## Historic Landmarks and Preservation Districts Commission

### Report to Committee

**Case No:** 23-COA-0018  
**Classification:** Committee Review

**Property Address:** 285 Pope St.

Figure 1 and 2. Designation Photos of 285 Pope St.

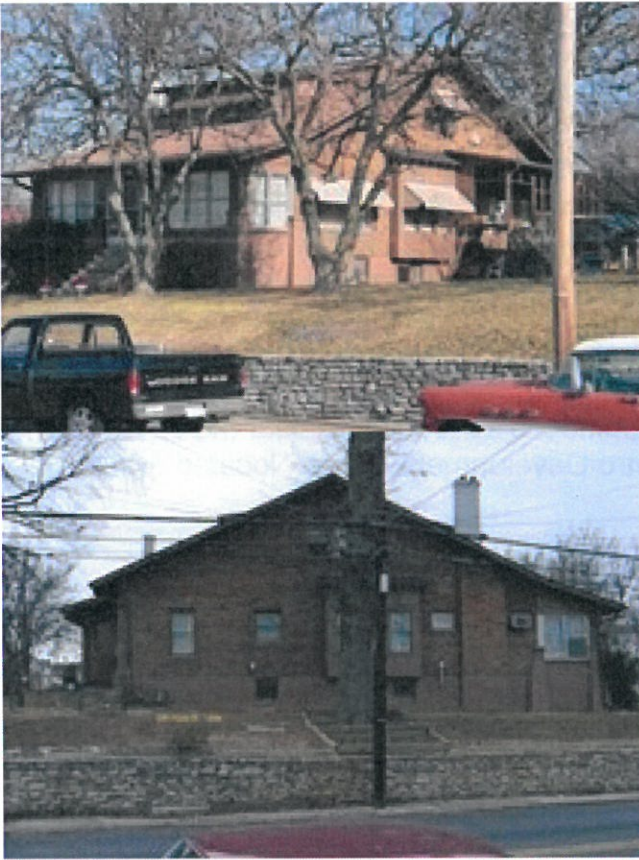
The project generally does not meet the Clifton Preservation District design guidelines for **Paint and Coatings** and **Masonry**. The brick on the house and garage had never been painted (**Figure 1 and 2 below**), with the exception of the porch parapet walls, porch columns, chimney, and first level bay projections. Thus its painting does not conform with guidelines **P1** and **M1 (Figure 3 below)**.

The project generally does not meet the Clifton Preservation District design guidelines for **Windows**. Approximately 29 historic wood windows have been replaced without a COA, and of those approximately 18 are street facing. Their conditions were not able to be assessed by staff, or reviewed by the Clifton ARC prior to their replacement, which does not conform with **W1**. The vinyl replacement windows that have been installed do not convey the same visual appearance as the historic wood windows. Their glass is tinted, their muntins are internal instead of external, their muntin patterns do not match those of the historic wood windows, they have different reveal depths than the historic wood windows, and at least 8 of them do not function in the same way as the historic wood windows (**Figure 4 and 5 below**). They do not conform with guidelines **W2, W4, W5 or W7**.

1. **The paint shall be removed from the bricks. The applicant shall test gentle treatments to remove the paint in an inconspicuous location.**
2. **Landmarks staff shall be consulted for recommended products. The applicant shall not sandblast, pressure wash or use acid-based cleaners to remove the paint. Solvent-based chemical strippers are preferred over sandblasting or pressure washing the masonry surface.**

3. **The windows facing Pope St. and Brownsboro Rd. shall be replaced with wood or wood clad windows that convey the same appearance and operate in the same way as the original historic wood windows that were removed.**
